SUBJECT: Architecture Panel Inc.
Rezoning / 45905 Alexander Avenue DATE: October 19, 2023

DEPARTMENT: Planning
RZ001626, DVP001373 & DP001564 PREPARED BY: Gaitlyn Wiltsie / mb

**STAFF REPORT ON REZONING RZ001626, DEVELOPMENT VARIANCE PERMIT DVP001373 &
DEVELOPMENT PERMIT DP001564 APPLICATIONS**

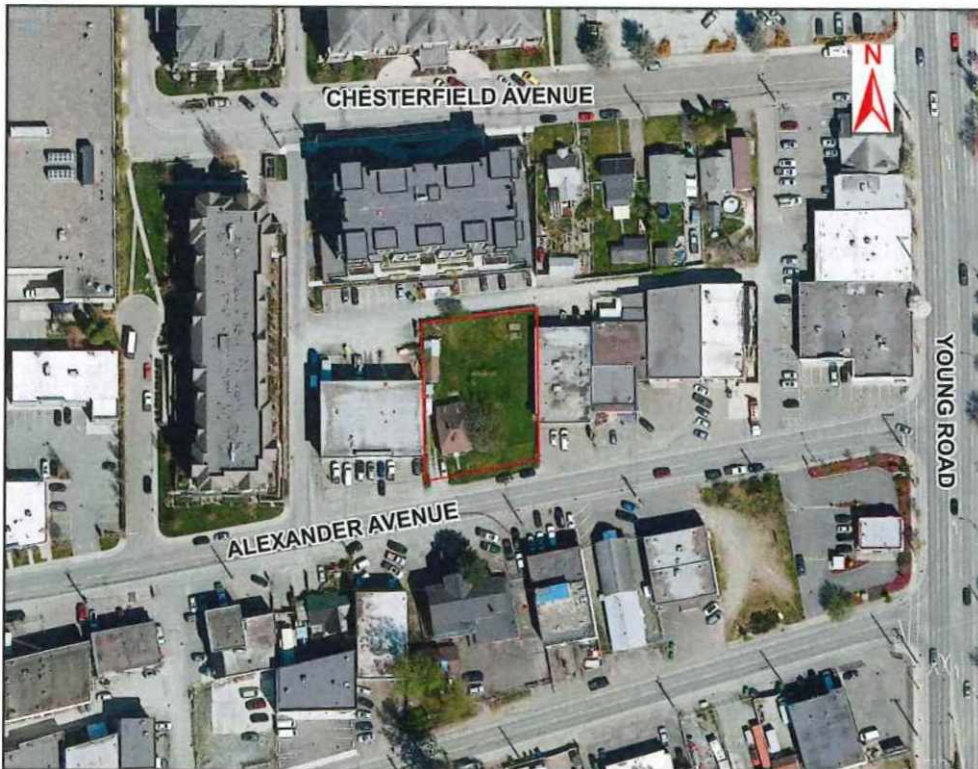
The applicant requests a reduction to the minimum interior side lot line (ISLL) setbacks along the west and east property lines for the 4th and 5th storeys. The R5 Zone requires an ISLL setback to increase by 0.75m per storey beyond the third storey to a maximum of 9m. Considering this, an ISLL

setback of 6.75m is required for the 4th storey and 7.5m for the 5th storey. As shown below, the applicant requests to reduce these setbacks to 6m for the 4th storey and 6.75m for the 5th storey.
